Z-97
(2016)

SITE PLAN FOR
Single-Family Homes (RA-5)
#1189 Vester Drive
Landlot 962 of the 16th District
Marietta, Cobb County, Georgia

PETITION NO: Z-97

ZONING COMMENTS:

SHEET NUMBER
1

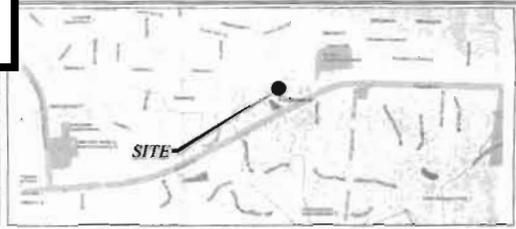
As the proposed development abuts a cemetery to the west, a cemetery buffer may be required along this side that is not shown on the current site plan. Also, a ten foot landscape buffer will be required along the northern edge where the development abuts a more restrictively zoned property.

Cemetery Preservation: Zoning petition Z-97 2016 (in land lot 962 of the 16th District) shows the presence of Antioch cemetery on the western border of the project. The Cobb Cemetery Preservation Ordinance and the County Development Standards for Cemeteries call for:

- A. Prepare a site plan identifying the full boundaries with a metes and bounds description.
- B. Provide a fifty (50) foot undisturbed natural buffer from the common property line; or a fifty (50) foot undisturbed natural buffer around the perimeter of the outermost burials of the cemetery; whichever provides the greatest protection for the cemetery.

- C. Lots adjacent to the fifty (50) foot undisturbed natural buffer shall have setbacks in addition to the buffer.
- D. The fifty (50) foot undisturbed natural buffer shall be recorded as a conservation easement with the Cemetery Preservation Commission having third party right of enforcement.

- E. Provide and install a permanent six (6) foot chain link fence on the outer perimeter of the fifty foot undisturbed buffer. Fence must be 9 gauge with top and bottom rails and fence posts must be set in concrete. Fence may be upgraded to black vinyl coated chain link and/or wrought iron.

- F. Provide and install an orange protective fence on the outer perimeter of the fifty (50) foot undisturbed natural buffer before beginning construction. The protective fence to be maintained in good repair throughout the development phase of the project. At completion of the project, the orange protective fence shall be removed from the premises.

- G. Permanent signs stating CEMETERY PRESERVATION BUFFER – DO NOT DISTURB shall be erected at fifty (50) foot intervals along the outer perimeter of the fifty (50) foot undisturbed natural cemetery preservation buffer.

- Provide comprehensive hydrology/stormwater controls to include development of out parcels.
- Submit all proposed site improvements to Plan Review.
- Any **spring activity** uncovered must be addressed by a qualified geotechnical engineer (PE).
- Structural fill must be placed under the direction of a qualified registered Georgia geotechnical engineer (PE).
- Existing facility.
- Project must comply with the Water Quality requirements of the CWA-NPDES-NPS Permit and County Water Quality Ordinance.
- Water Quality/Quantity contributions of the existing lake/pond on site must be continued as baseline conditions into proposed project.
- Calculate and provide % impervious of project site.
- Revisit design; reduce pavement area to reduce runoff and pollution.

- No Stormwater controls shown _____
- Copy of survey is not current – Additional comments may be forthcoming when current site conditions are exposed.
- No site improvements showing on exhibit.

1. This site is located at the northwest intersection of Roswell Road and Vester Drive. Approximately one quarter of the site is currently occupied by a 0.5 acre lake that is located in the center of the parcel. The storage effect of this lake provides a stormwater mitigating benefit for downstream property owners that must be maintained or recreated within this redevelopment.
2. The proposed layout will also need to accommodate an adequate drainage system to convey the existing upstream runoff through the site. This will require a 20-foot drainage easement along the rear of Lot 4 and between Lots 3 & 4.

Recommend curb and gutter along both sides and sidewalk along one side of proposed development roadway.

Recommend curb, gutter, and sidewalk along the Roswell Road frontage.

Recommend a no access easement along the lots that border the Roswell Road frontage.

Recommend entrance be located a minimum of 50 feet from the intersection of Vester Drive and Roswell Road.

1. Maximum of three (3) units per acre;
2. Site plan to be approved by the District Commissioner;
3. Code-required ten foot landscape buffer adjacent to northern neighbors to be reviewed and approved by County Arborist;
4. Cemetery Preservation Commission comments and recommendations;
5. Water and Sewer Division comments and recommendations;
6. Stormwater Management Division comments and recommendations; and
7. Department of Transportation comments and recommendations.
